**CHARTER TOWNSHIP OF VAN BUREN
PLANNING COMMISSION
September 27, 2023
MINUTES**

**Subject: VBT-23-031 Ashley Capital Crossroads Distribution Center North – Building 11
Special Land Use Review #1**
Plans Dated August 17, 2023; Received on August 29, 2023

**Subject: VBT-23-031 Ashley Capital Crossroads Distribution Center North – Building 11
Site Plan Review #2 (Preliminary)**
Revised Plans Dated August 17, 2023; Received on August 29, 2023

SOUTH ELEVATION

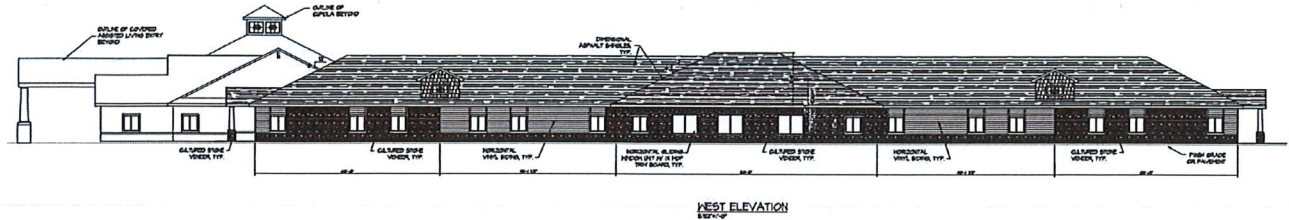
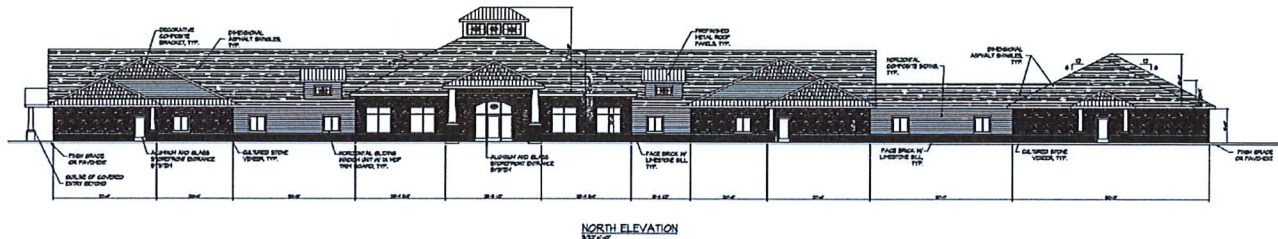
Our comments below include a summary of the changes to the facade from the originally approved plan and proposed additional changes by the applicant in an attempt to correct the violations.

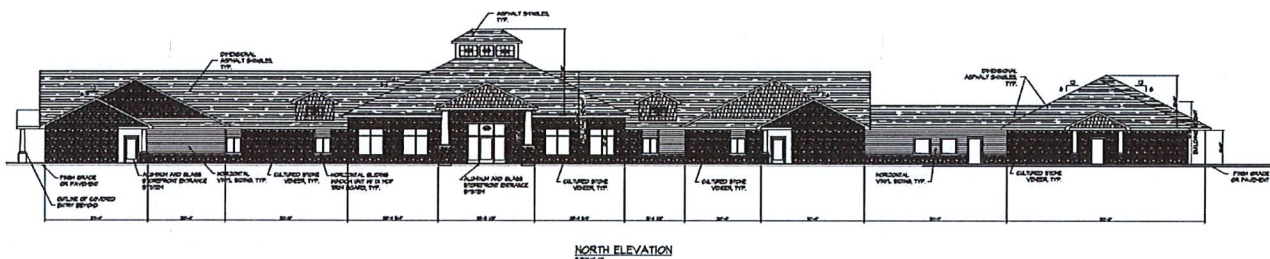
North Façade. The north facade does not match the elevation approved by the Planning Commission.

- Roof dormers are of a different design.
- No metal roof accents on the dormers.
- A new door has been added to the corridor connecting the memory care with the assisted living portion of the building, resulting in the replacement of 2 evenly spaced windows with square windows and a door. The location is recessed and not a part of the main façade wall. We have requested an updated site plan to ensure the door opens up onto a sidewalk connector and not a landscape area.
